Subject: **Supercharger Service Part Update**

No. **2008-12**

This bulletin is concerning all supercharger retaining nuts found in the Supercharger Repair Kits.

RETAINING NUT

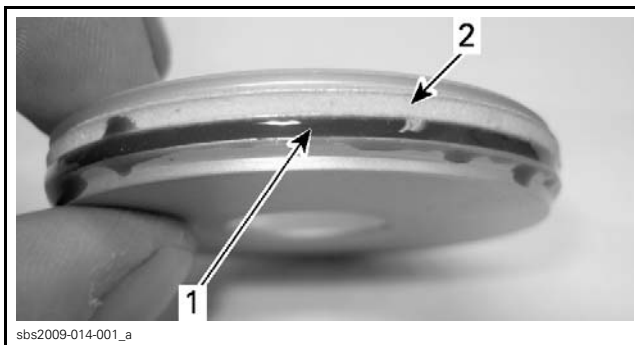
As a running change at Rotax facilities during MY2008 supercharger production, the amount of scotch grip was reduced on retaining nut.

LOCTITE 243 (BLUE) (P/N 293 800 060)[†] should be applied around (360°) of the first thread turn, as shown by the picture, prior to installation.

1. Scotch grip
2. Apply LOCTITE 243 (BLUE) (P/N 293 800 060) here

NOTICE Care must be taken not to put too much Loctite on to prevent getting it on the bearing.
